## dsPIC33EPXXXGS70X/80X Family Silicon Errata and Data Sheet Clarification

The dsPIC33EPXXXGS70X/80X family devices that you have received conform functionally to the current Device Data Sheet (DS70005258C), except for the anomalies described in this document.

The following typographic corrections and clarifications are to be noted for the latest version of the device data sheet (DS70005258C):

FIGURE 1:

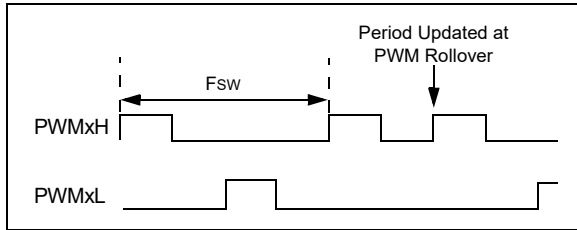
When the PWM module is configured for Push-Pull mode (IOCONx[11:10] = 0b10) with the Enable Immediate Period Update bit enabled (PTCON [10] = 1), a write to the Period register that coincides with the period rollover event may cause the push-pull output logic to produce back-to-back pulses on the PWMx pins (see Figure 1).

Ensure that the update to the PWM Period register occurs away from the PWM rollover event by setting the EIPU bit (PTCON[10] = 1). Use either the PWM Special Event Trigger (SEVTCMP) or the PWM Primary Trigger (TRIGx) to generate a PWM Interrupt Service Routine (ISR) near the start of the PWM cycle. This ISR will ensure that period writes do not occur near the PWM period rollover event.

FIGURE 2: EXAMPLE FOR REDUNDANT OUTPUT MODE

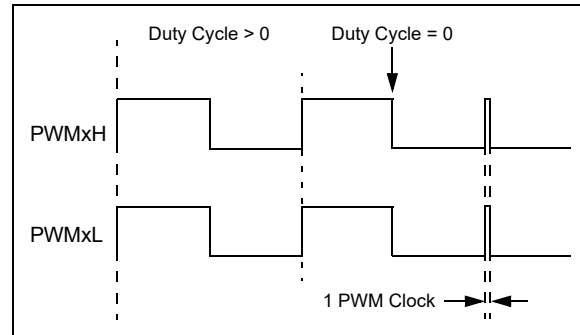
In the Redundant Output mode (IOCONx[11:10] = 0b01) and Push-Pull Output mode (IOCONx[11:10] = 0b10), with the Immediate Update Enable bit disabled (PWMCONx[0] = 0), when the Duty Cycle register is updated from a non-zero value to zero, a glitch pulse of a width equal to 1 PWM clock will appear at the next PWM period boundary, as shown in Figure 2 (for the Redundant Output mode). The Duty Cycle register refers to the PDCx register if PWMCONx[8] = 0 or the MDC register if PWMCONx[8] = 1.

If the application requires a zero duty cycle output, there are two possible work around methods:

1. Use the PWM override feature to override the PWM output to a low state instead of writing to the Duty Cycle register. In order to switch back to a non-zero duty cycle output, turn off the PWM override. The override-on and override-off events must be timed close to the PWM period boundary if the IOCONx register has been configured with IOCONx[0] = 0 (i.e., output overrides through the OVRDAT[1:0] bits occur on the next CPU clock boundary).
2. Enable the Immediate Update Enable bit (PWMCONx[0] = 1) while configuring the PWMx module (i.e., before enabling the PWMx module, PTCON[15] = 1). With the Immediate Update enabled, writes to the Duty Cycle register can have an immediate effect on the PWM output. Therefore, the duty cycle write operations must be timed close to the PWM period boundary in order to avoid distortions in the PWM output.

**FIGURE 3: SIMPLIFIED BEHAVIOR**

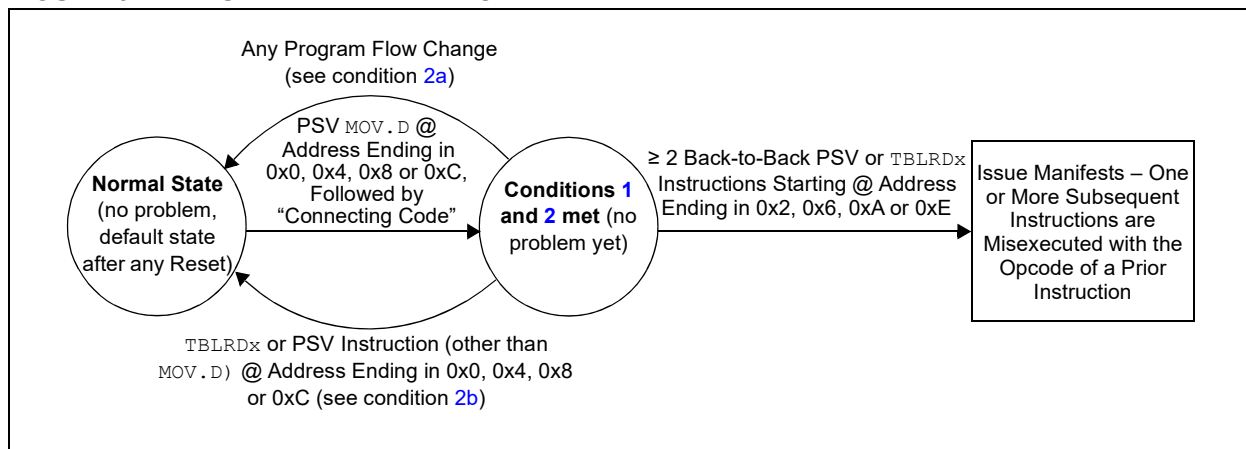
When two or more data Flash read instructions (via Program Space Visibility (PSV) read or Table Read) are executed back-to-back, one or more subsequent instructions can be misexecuted when all of the conditions in [Table 4](#) occur.

[Figure 3](#) provides an example of the effective behavior.

The issue can be avoided by ensuring any one or more of the requirements are not met. For example:

1. All instances of PSV `MOV.D` can be replaced with two PSV `MOV` instructions instead. Non-PSV `MOV.D` instructions acting on RAM/SFRs do not need to be modified; or
2. If not already present, a program flow change instruction (such as `BRA $+2`) can be inserted above back-to-back data Flash read sequences; or
3. Back-to-back data Flash read instruction sequences can be broken up by inserting a non-Flash read instruction (such as a `NOP`), in between the Flash read instructions; or
4. The alignment of the code can be shifted to avoid the required opcode location addresses.

**FIGURE 4-2: PROGRAM MEMORY MAP FOR dsPIC33EP128GS70X/80X DEVICES**

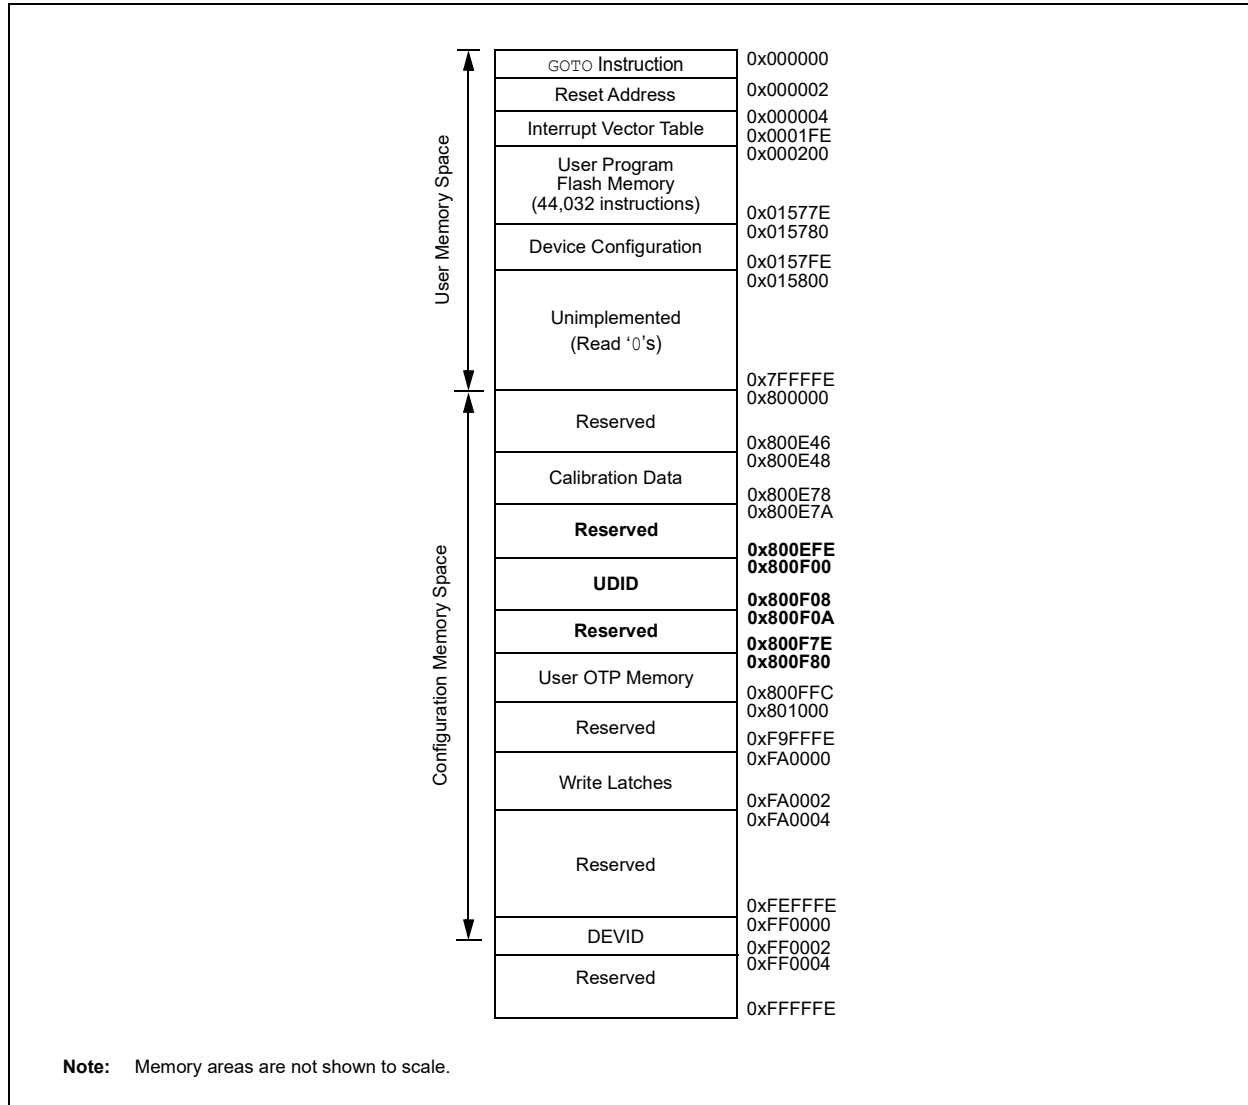
In Figure 4-2, the following changes have been made as shown in **bold**:
